ORIGINATION FORM

Proposed Revisions to a Standard Plans Index

Index Number: 700-120
Sheet Number (s): All
Index Title: Enhanced Highway Signing Assemblies

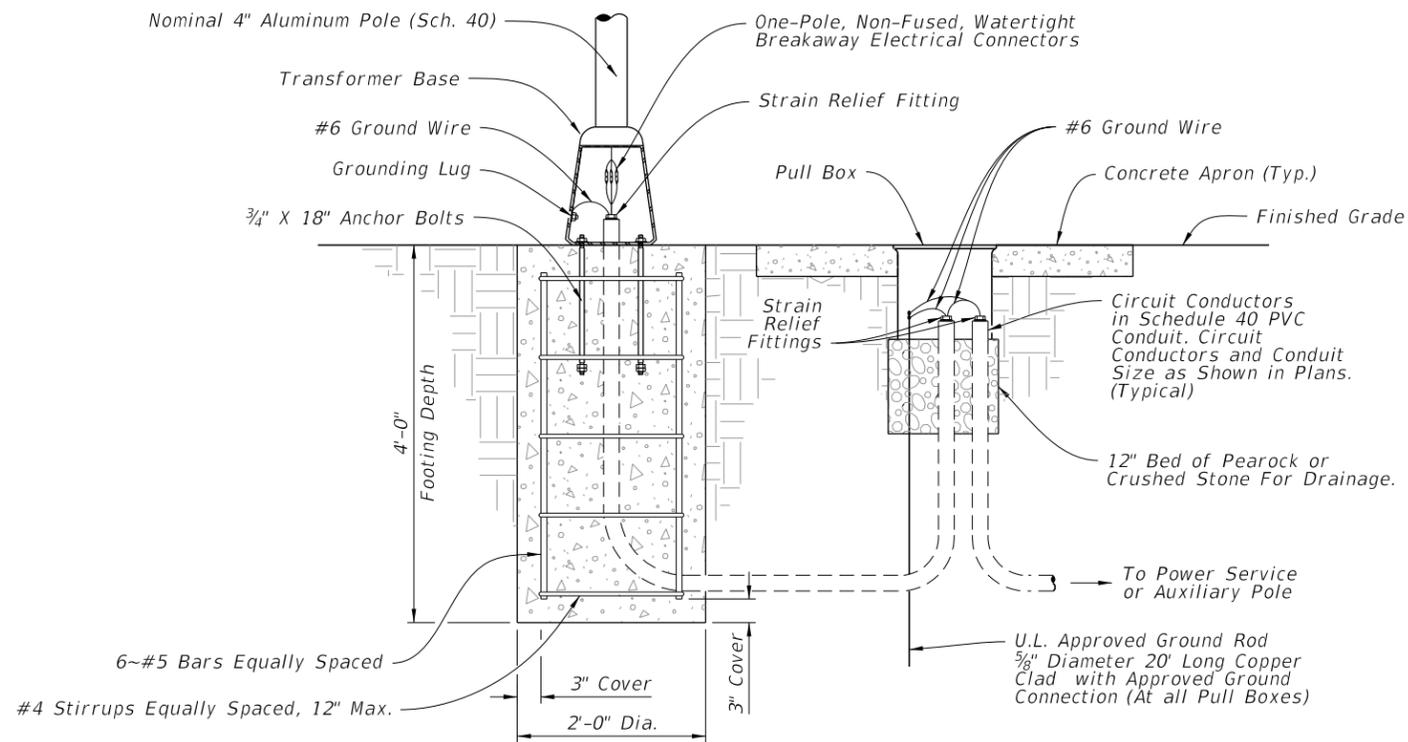
All Sheets: Renumber
Sheet 1: Added New Sheets to Table of Contents.
Sheet 3: New Sheet - Spread Footing Foundation.
Sheet 12: New Sheet - Roadside Sign Assembly-9.
Sheet 13: New Sheet - Roadside Sign Assembly-10.
Sheet 14: New Sheet - Roadside Sign Assembly-11.

ADDED NEW SHEETS

TABLE OF CONTENTS:	
Sheet	Description
1	General Notes and Contents
2	Conduit, Wiring, and Foundation Details
3	Spread Footing Foundation
4	Roadside Sign Assembly-1
5	Roadside Sign Assembly-2
6	Roadside Sign Assembly-3
7	Roadside Sign Assembly-4
8	Roadside Sign Assembly-5
9	Roadside Sign Assembly-6
10	Roadside Sign Assembly-7
11	Roadside Sign Assembly-8
12	Roadside Sign Assembly-9
13	Roadside Sign Assembly-10
14	Roadside Sign Assembly-11
15	Overhead Sign Assembly

NEW SHEET 3

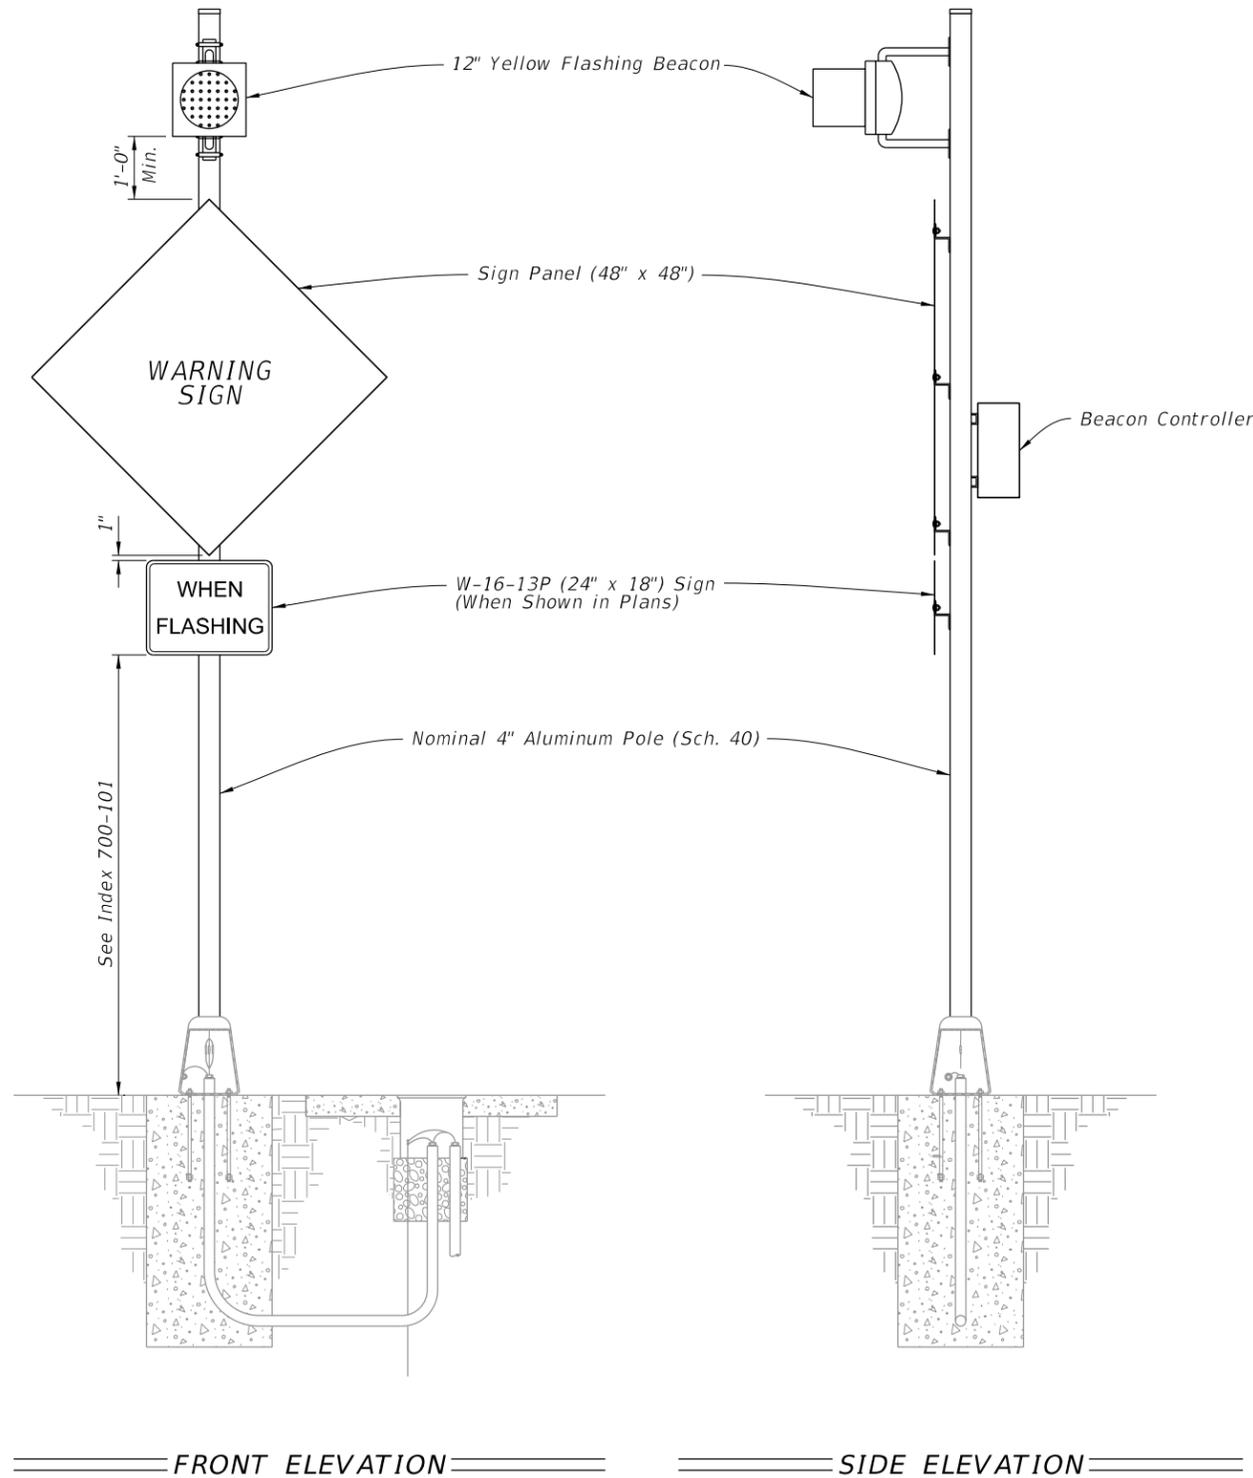
The districts have requested a spread footing foundation option be added.

1. Install the Spread Footing Foundation only where called for in the Plans.
2. SIDEWALK:
 - a. When abutting sidewalk, match the cross slope of the adjacent sidewalk or curb ramp where applicable. Maintain the minimum depth of footing.

- b. 1/2" expansion preformed joint filler required between sidewalk and spread footing.
 - c. Apply concrete surface finish to the top of the spread footing in accordance with Specification 522-7.

- d. Sidewalk placed on the other side or both sides of the spread footing is permitted where shown in the Plans.
3. Only use concrete riser when installed in-line with sidewalk curb that results in a drop off to the adjacent sidewalk.

4. For sidewalks greater than 6', match sidewalk width. Add one #4 transverse bar, top and bottom, per additional foot of spread footing to maintain at minimum the same reinforcement area per foot.

5. Base location can vary on spread footing. Location shown in Plans.

NEW SHEET 12

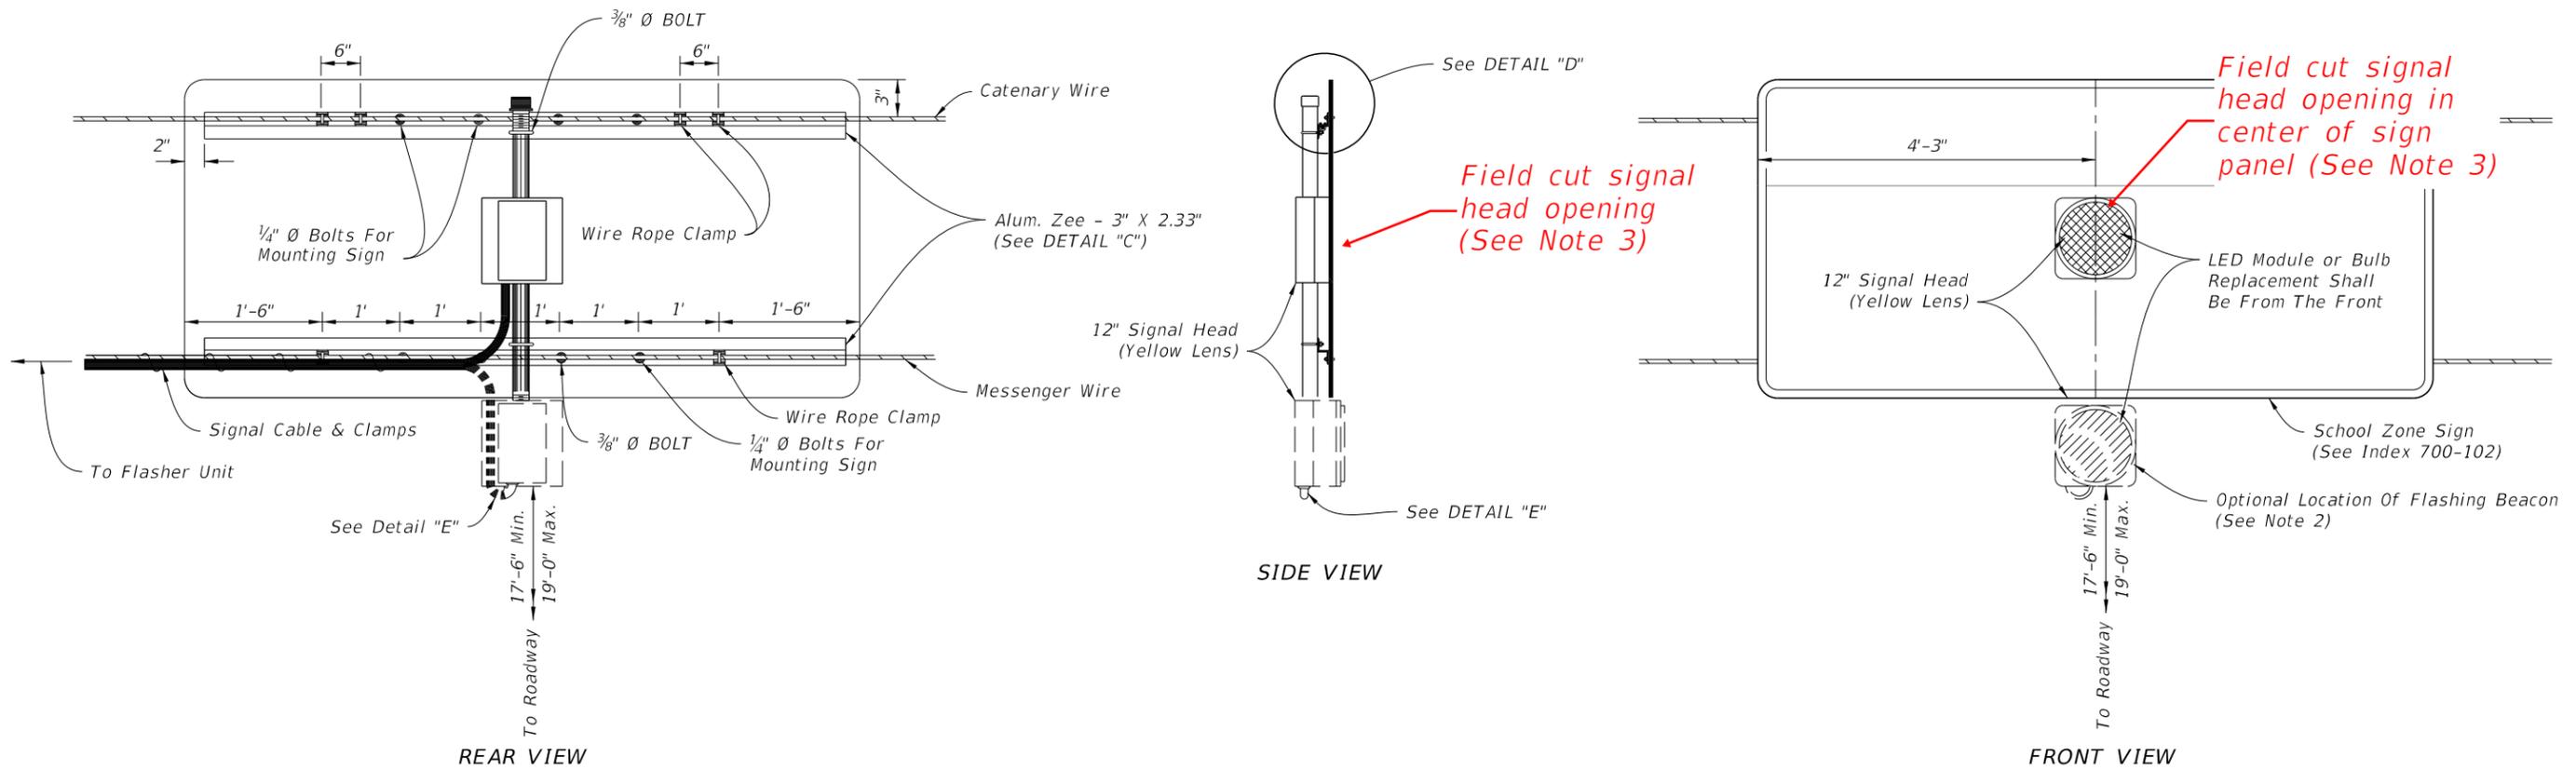
Three new Railroad Highlighted sign assemblies are being added as a result of input from the Rail Safety Task Team.

CHANGED TO: 15 of 15
OVERHEAD SIGN ASSEMBLY

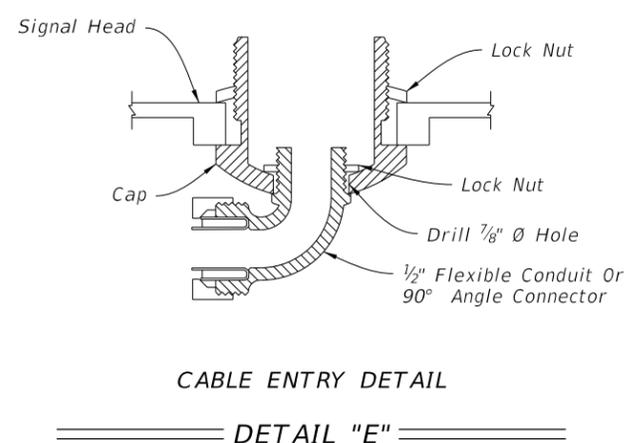
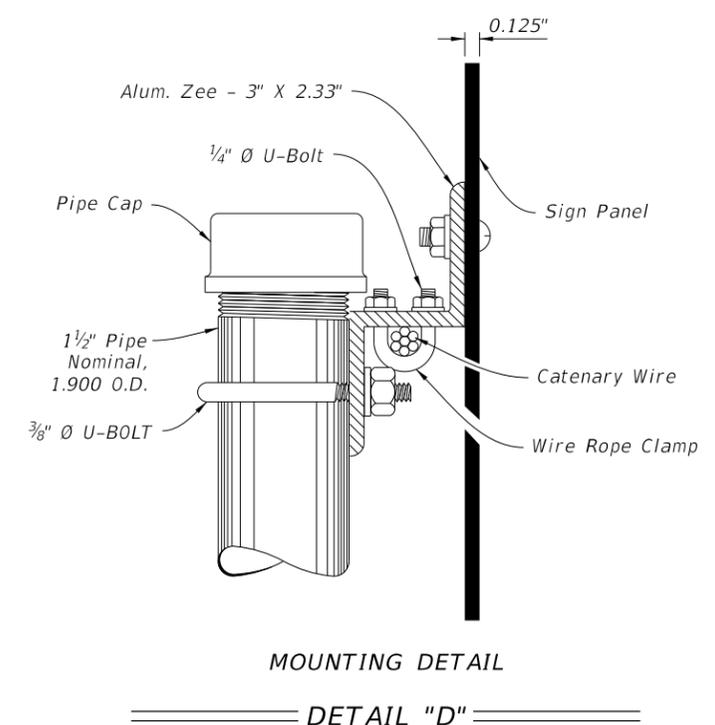
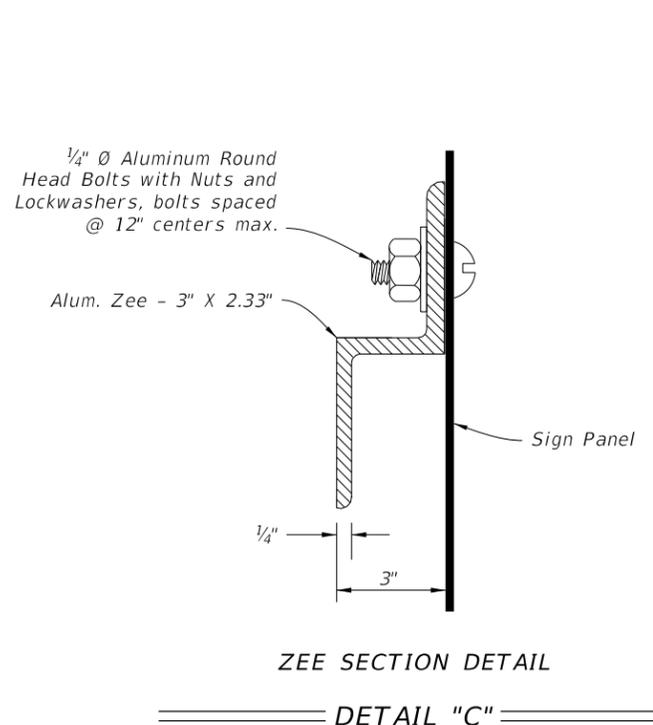
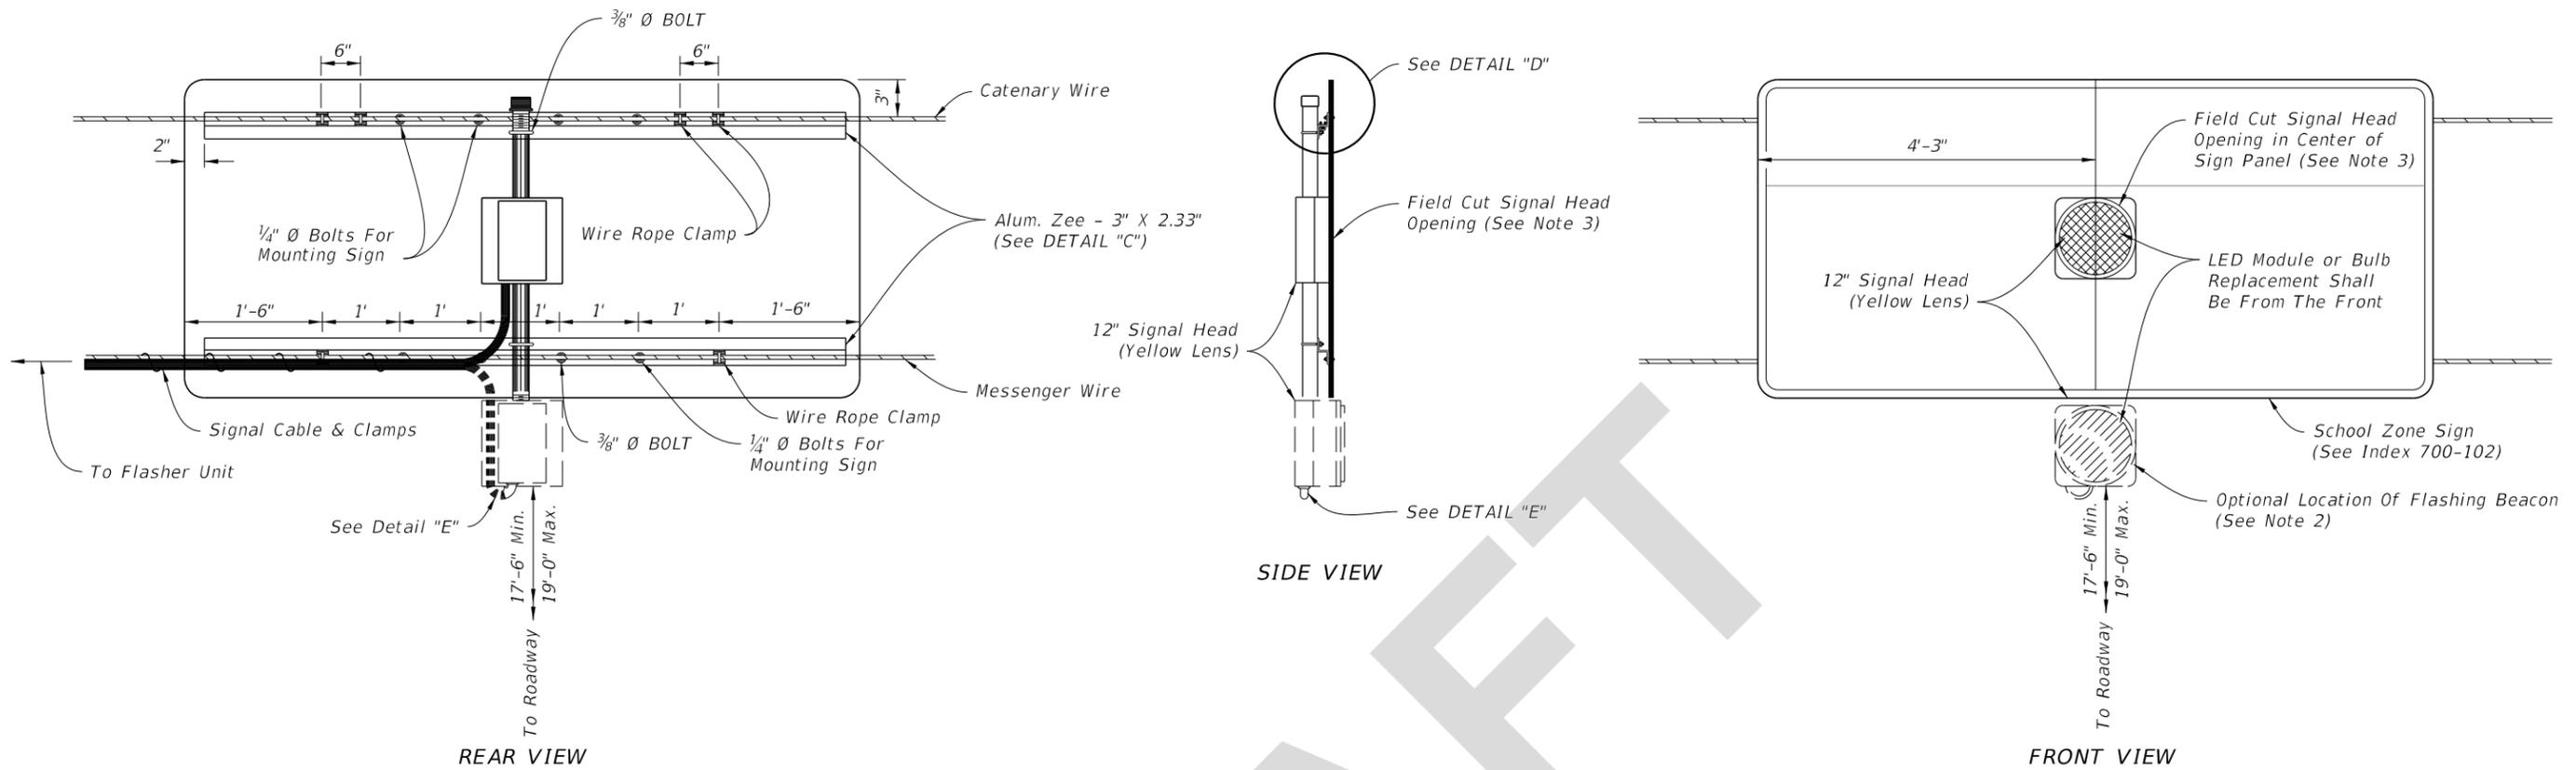
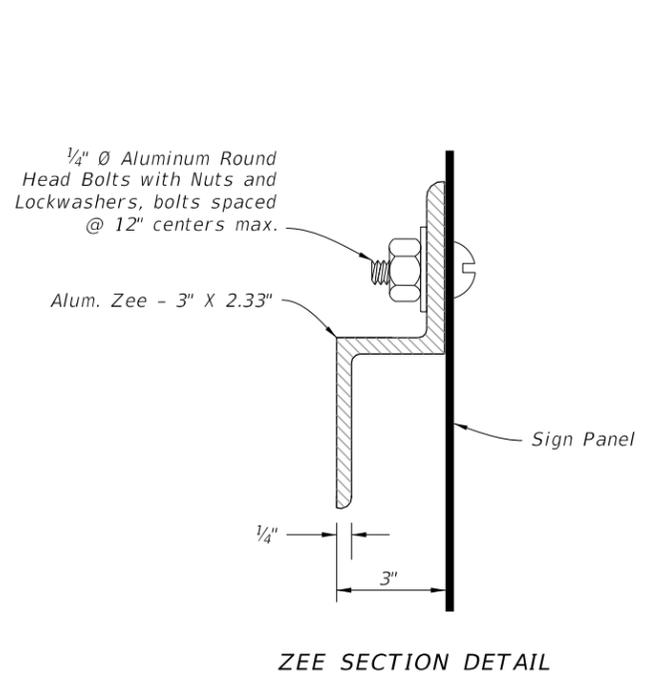
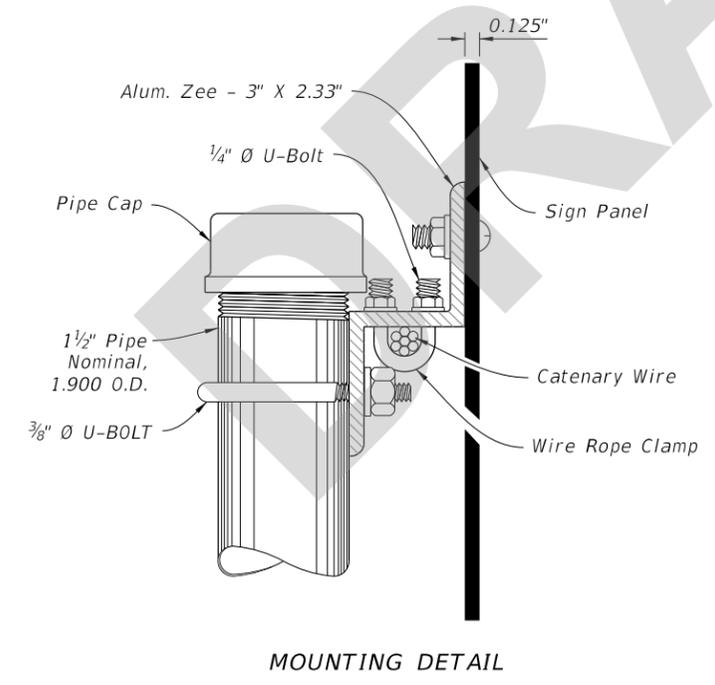
Added note 3 "Opening for 12" signal head shall be done in the field in accordance with the manufacturers specifications".

Added 2 call outs one on side view "Field cut signal head opening (See note 3) and the other for front view "Field cut signal head opening in center of sign panel (See Note 3).

1. Flasher unit and cabinet to be placed on the strain pole supporting overhead sign assembly or on service pole. The flasher unit not to overhang private property or sidewalk.
2. Optional flashing beacon will be called for in the Plans. They may be placed within or below the panel, or face to the rear.
3. Field install the opening for 12" signal head in accordance with the manufacturer's specifications

1. Flasher unit and cabinet to be placed on the strain pole supporting overhead sign assembly or on service pole. The flasher unit not to overhang private property or sidewalk.
2. Optional flashing beacon will be called for in the Plans. They may be placed within or below the panel, or face to the rear.
3. Field install the opening for 12" signal head in accordance with the manufacturer's specifications.
